REGULAR MEETING OF THE PLAN COMMISSION OF THE VILLAGE OF WILLOWBROOK TO BE HELD ON WEDNESDAY, DECEMBER 2, 2015 AT 7:00 P.M. AT THE VILLAGE POLICE STATION BUILDING, 7760 QUINCY STREET, IN THE VILLAGE OF WILLOWBROOK, DUPAGE COUNTY, ILLINOIS

STAFF REPORT TO THE PLAN COMMISSION

Case Number and Title: PC 15-06: 7501-7601 Quincy. ROC PUD

Action Requested: Approval of a special use for a Planned Unit Development and approval of a Preliminary and Final Plat of Subdivision and Preliminary and Final Plat of PUD

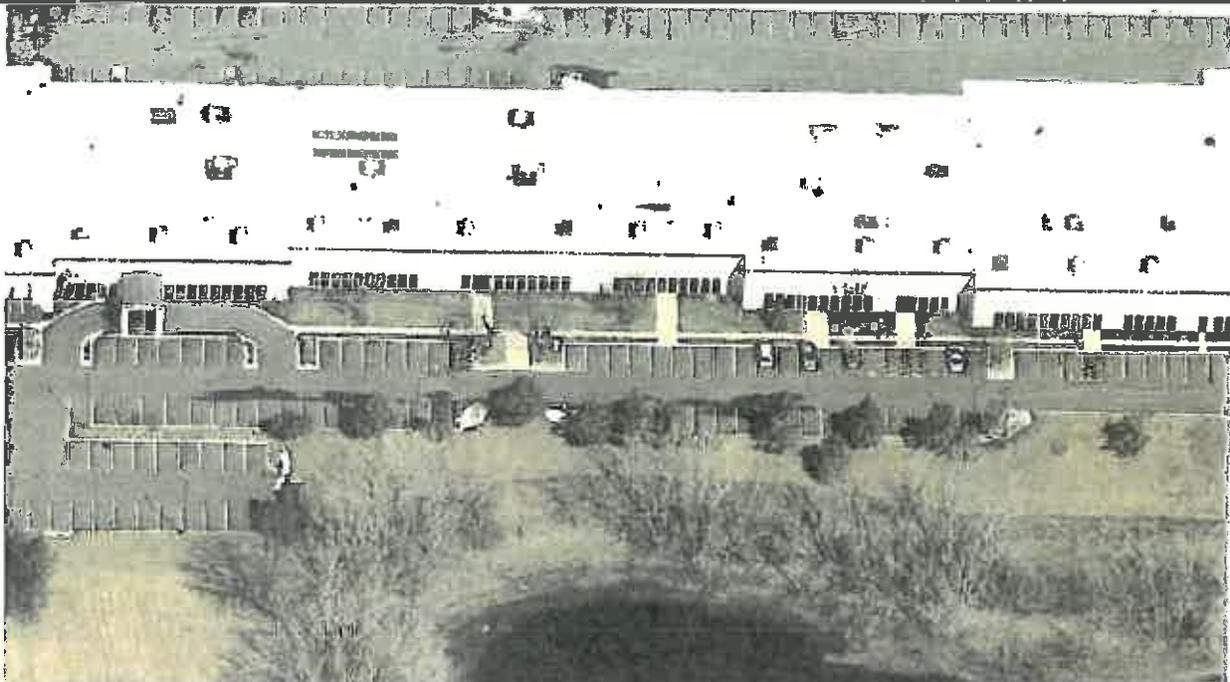
The images below were provided in the last staff report as an example of what would not be appropriate in this industrial park.

While the applicants colored elevations provided in the November staff report are shown to include appropriate colors in this industrial park, there were no details in the plan documents for Buildings A and B that would regulate these colors. Typically, PUDs provide sample materials and color details that are tied to the approval, however after speaking with the applicant further last week, these details are not available. The only alternative staff can offer given the applicant's desire for a quick recommendation is that the no building permits shall be issued unless final plan documents provide details that show colors in substantial compliance with the colors provided in the color renderings as determined by the Village Administrator. This has been included as a Condition of Approval.

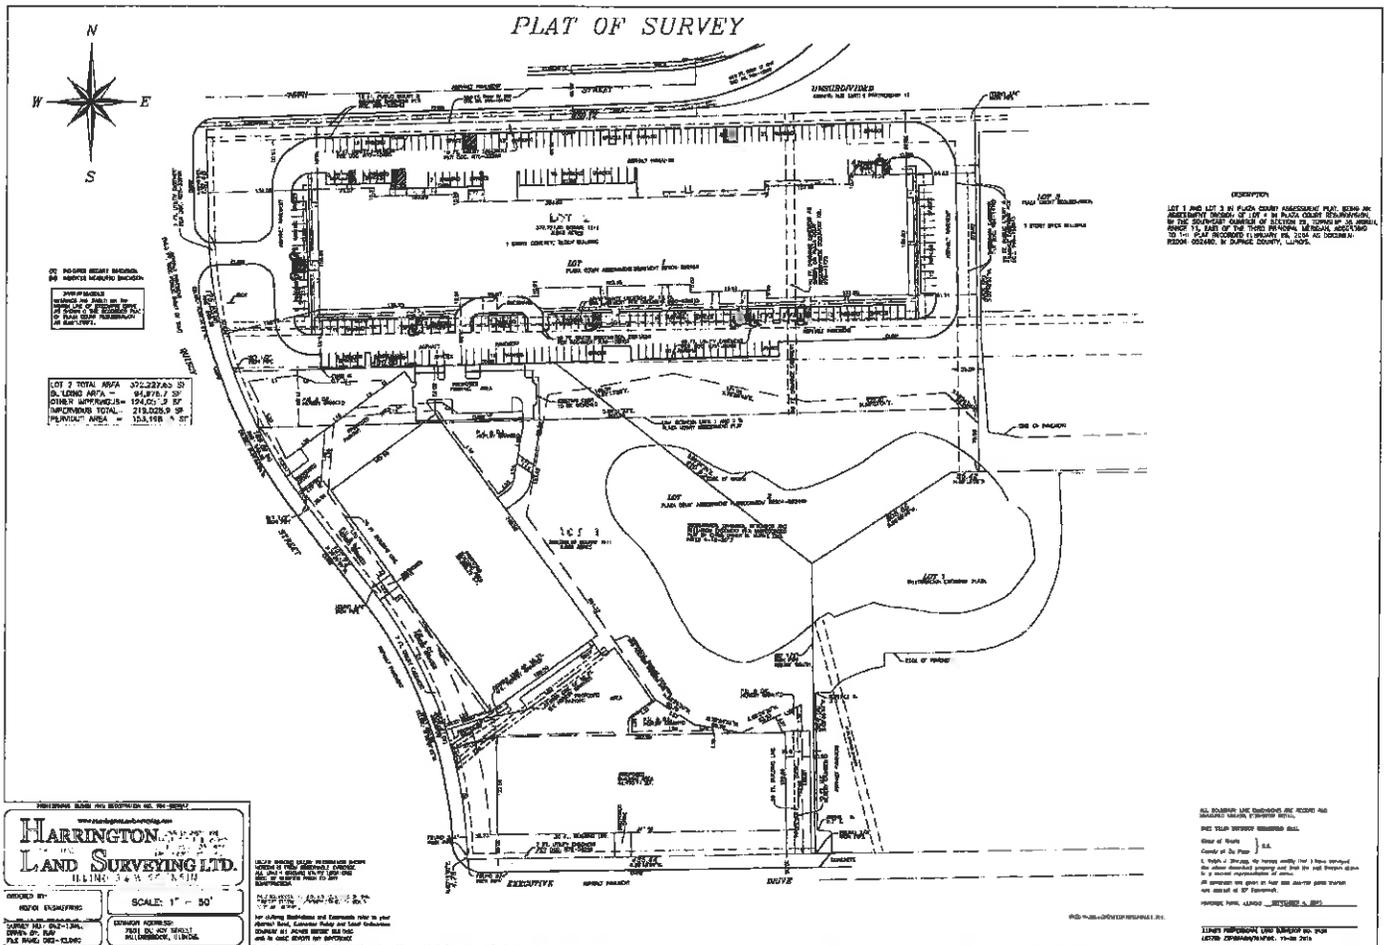
The applicant proposes to build two (2) buildings on a newly created southern lot. As can be seen in the picture below, each of the two new lots will include part of the pond. A larger copy of this image is provided as an attachment. Note that one of the new buildings would parallel and front Quincy, while the southern building would parallel Executive and have frontage on both Quincy and Executive Drive. The new northern building is intended for “drive-in” general goods storage and will contain 55,656 square feet. Access to this building will be possible via a shared access

point through the existing parking lot of the building to the north and full access drives on both the north and south sides of the building. Patrons wishing to purchase a storage space will enter the parking lot on the south side of the building to access the office area, which will be in the southwest corner of the north building. Patrons wishing to store their goods within this building will enter the building in their cars from the north side of the building which provides access to a garage door located on the east side of the building. Once they are finished, they will exit the building through an exit-only garage door to Quincy located midpoint in the building. The second building is intended for the storage of automobiles. It will contain 44,410 square feet. Access to the building will be via Quincy, located between the two buildings. Patrons will be able to drive into the building on the north, and out of the building on the south side to Executive Drive, where the driveway aligns with the access drive to the business across the street. The east side of this building also has a "fire lane" emergency only access drive on the east side of the building.

A larger version of this drawing is attached as Exhibit 3
